Approved Section 4.55 (.....2.....) Modification Application

In respect to.....SSD 7484.....

SANDSTONE PRECINCT
23-39 BRIDGE STREET
SYDNEY, NSW, 2000

DEMOLITION ELEVATIONS LANDS BUILDING - SOUTH AND EDUCATION BUILDING - SOUTH

1 GARDEN VILLA EAST CORNER DETAIL ELEVATION
1:20

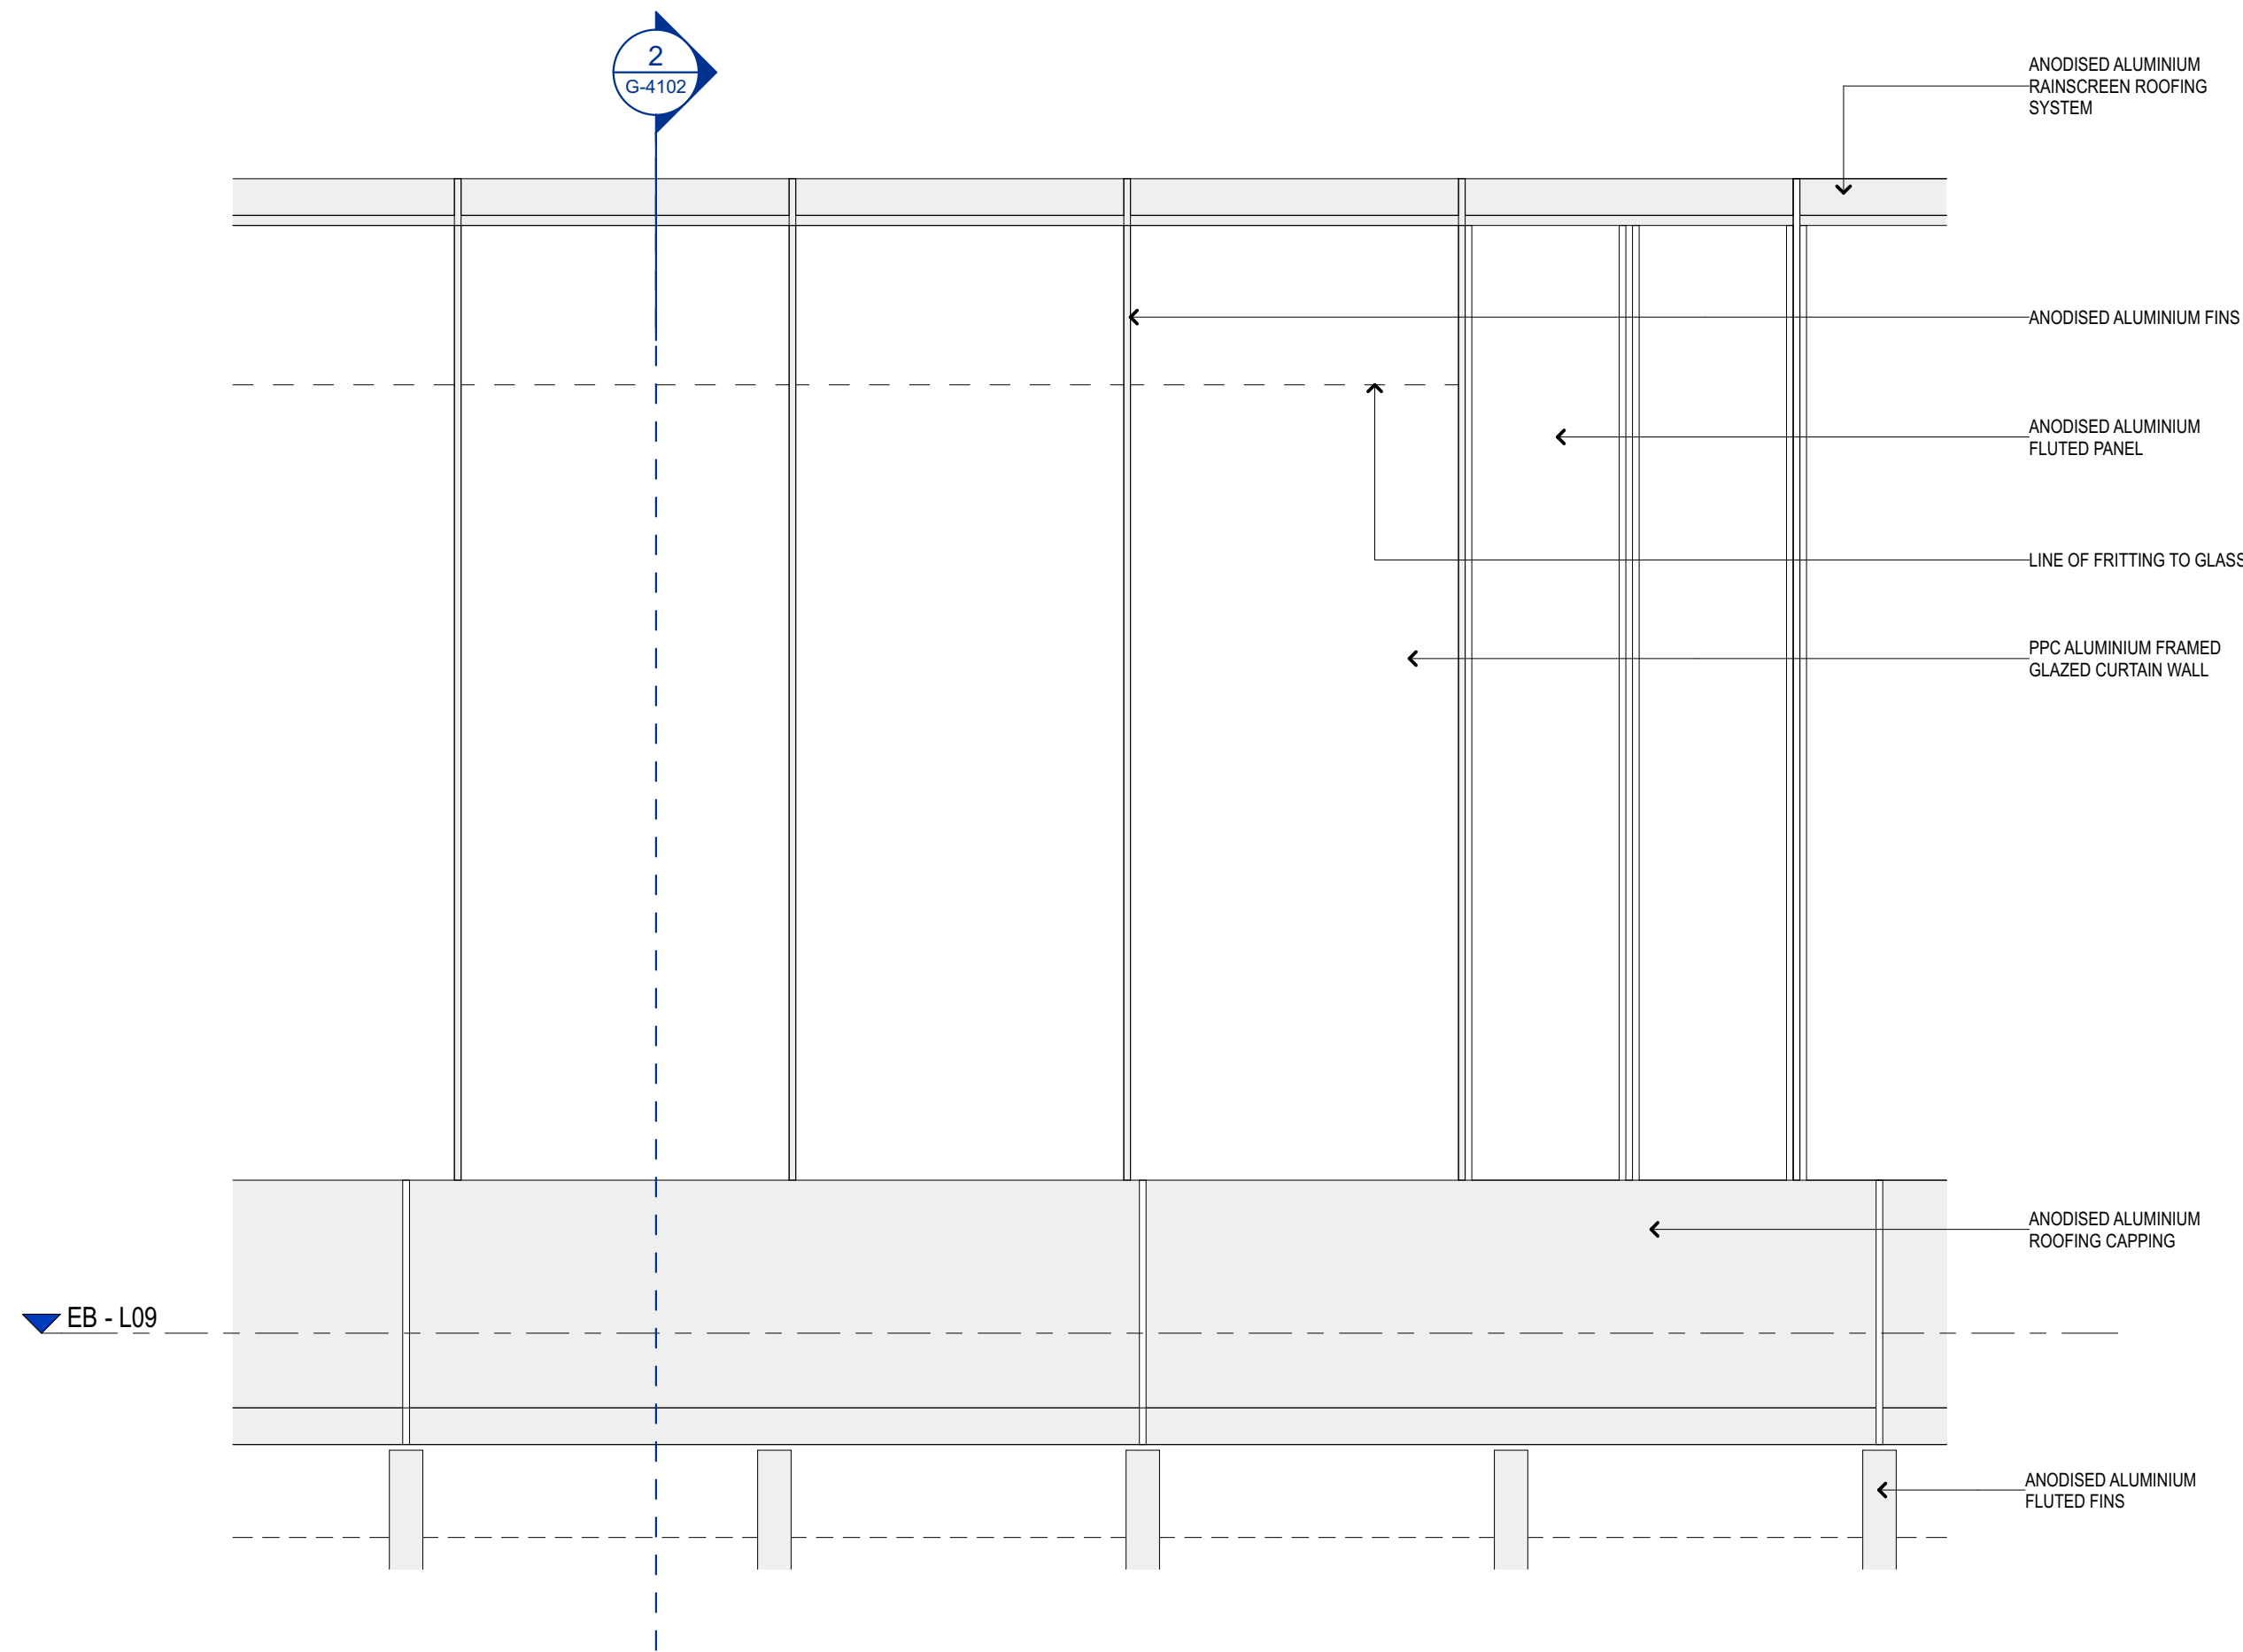
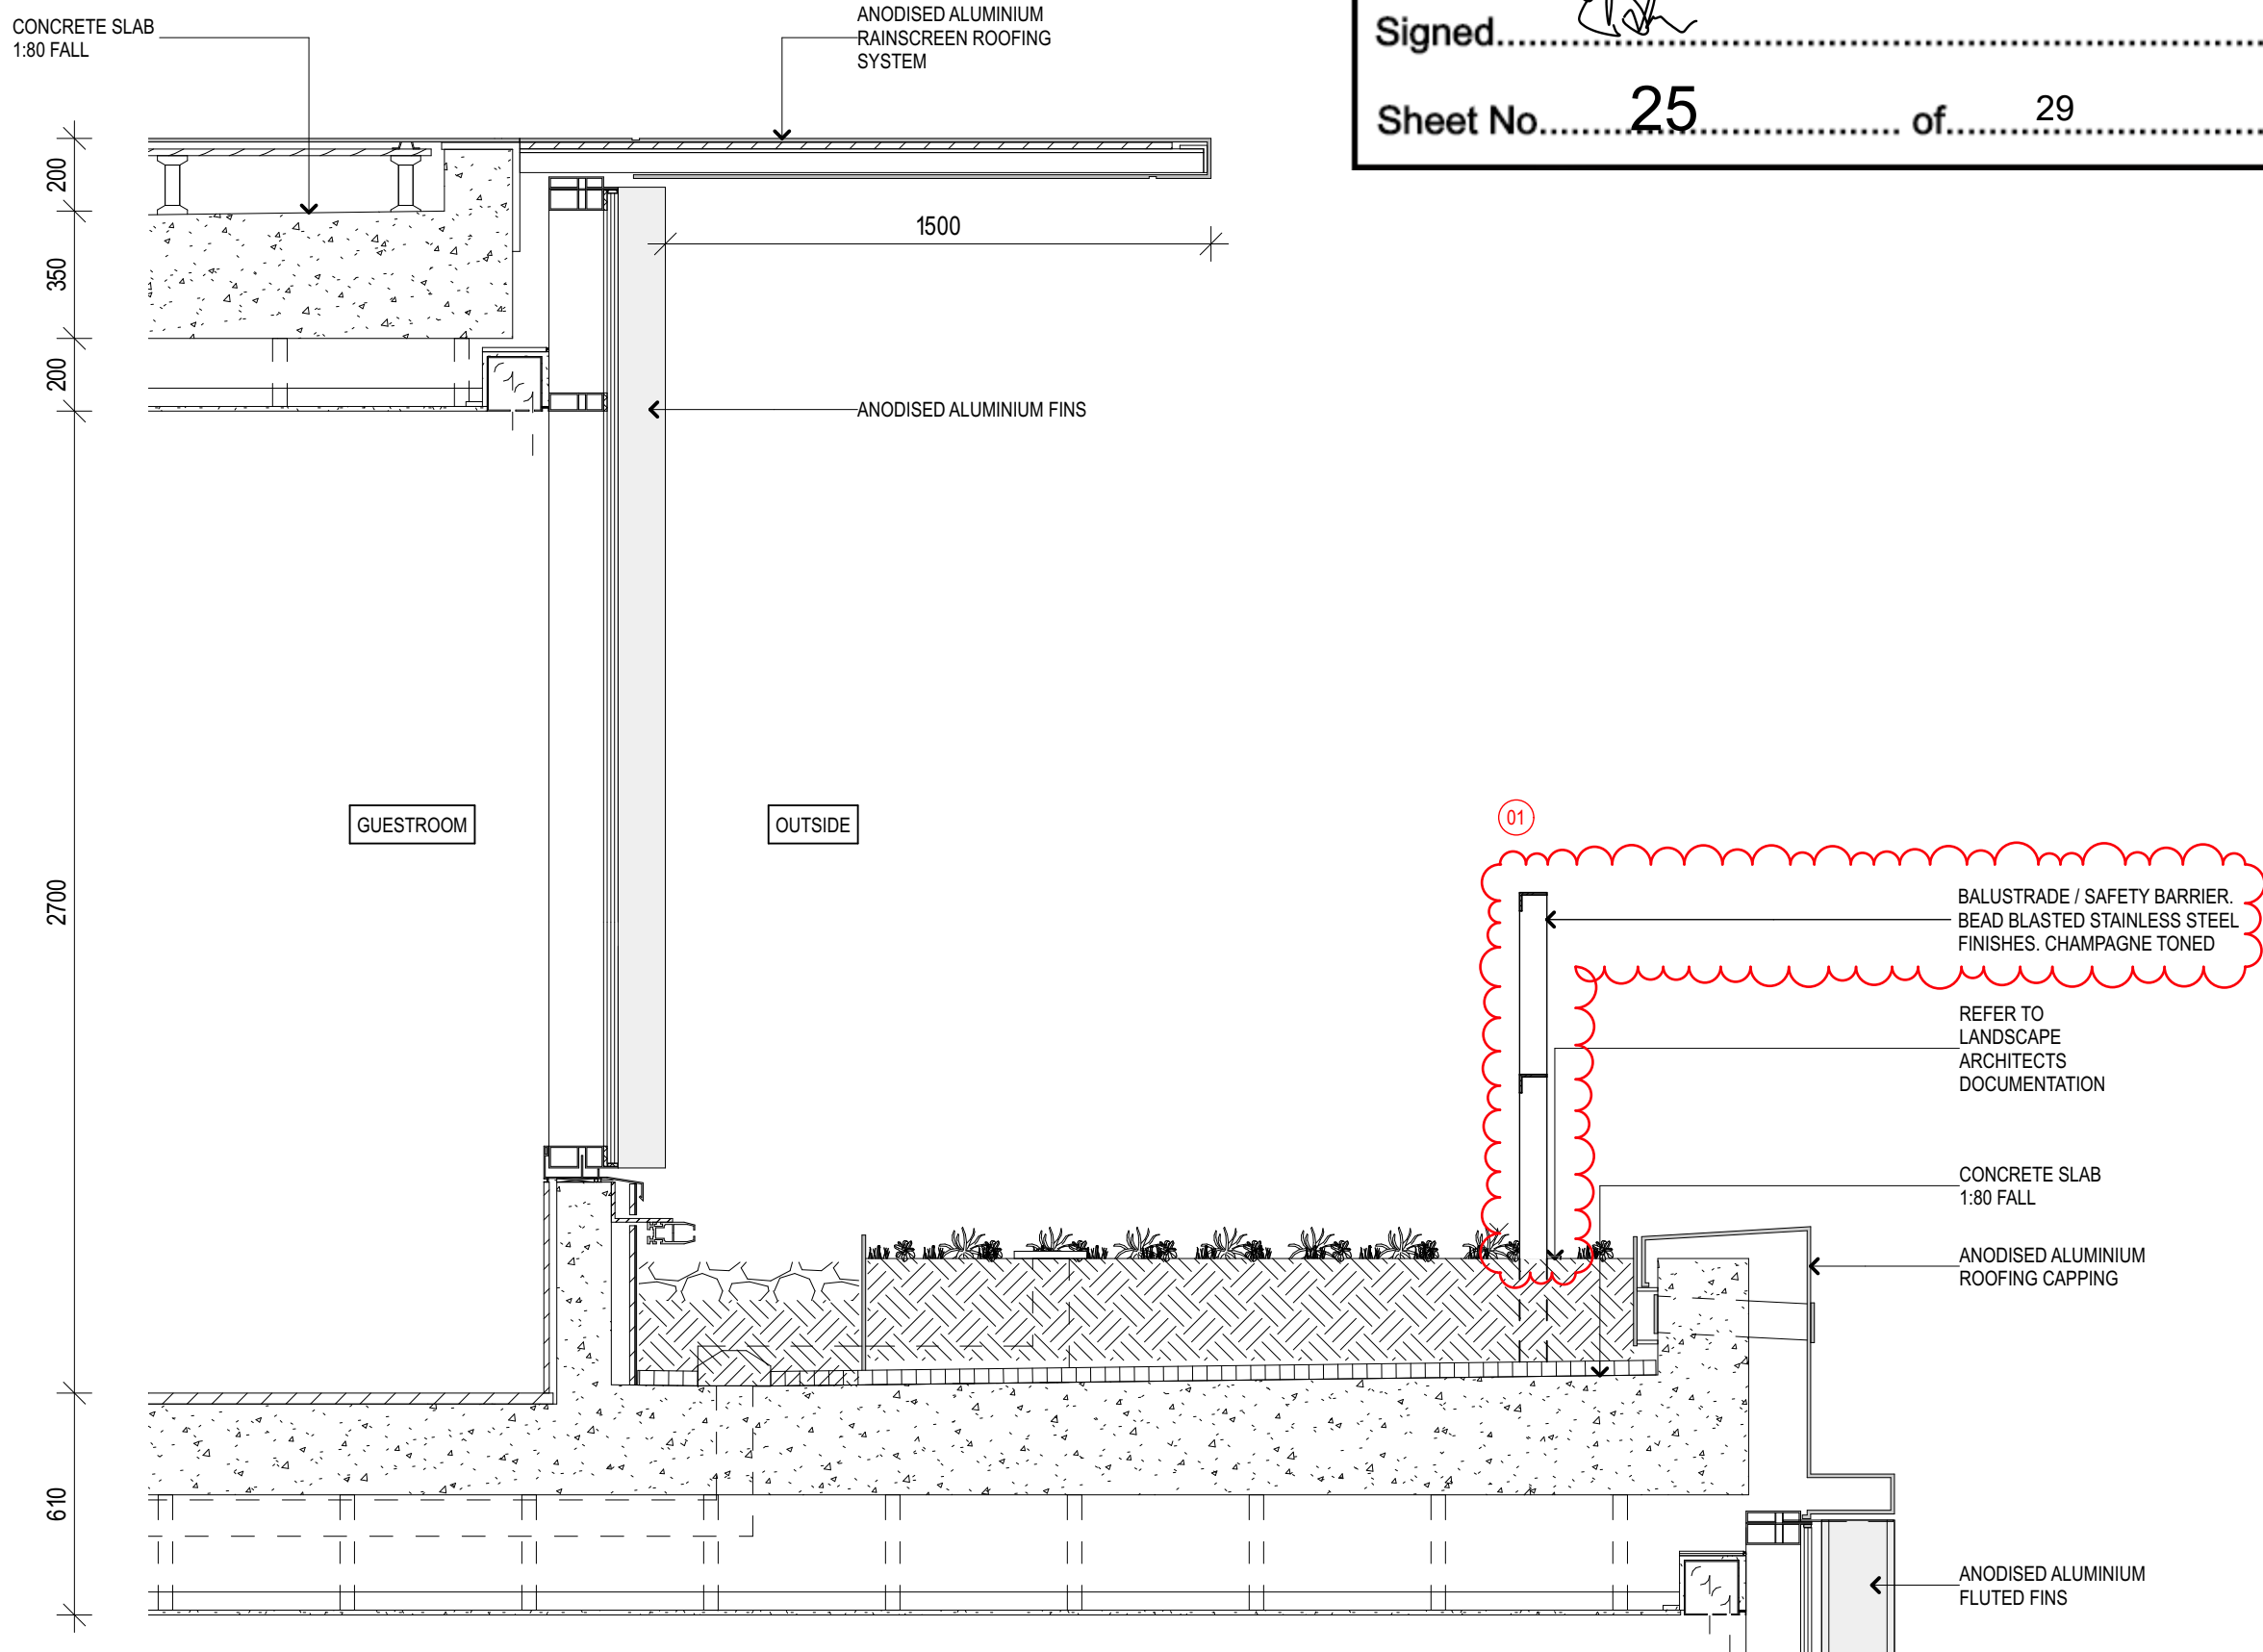
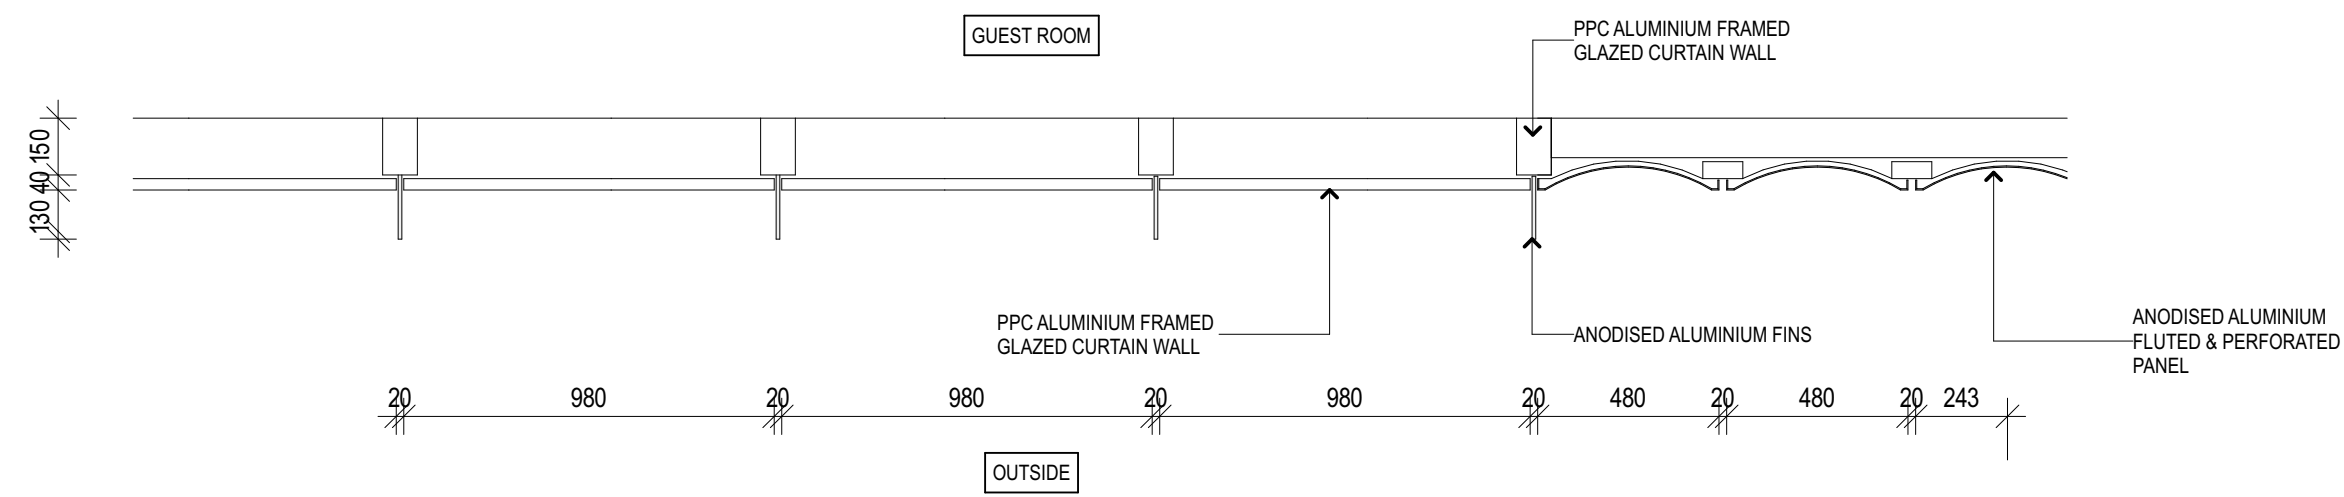
CHANGES LEGEND:	
01	ADDED BALUSTRADE
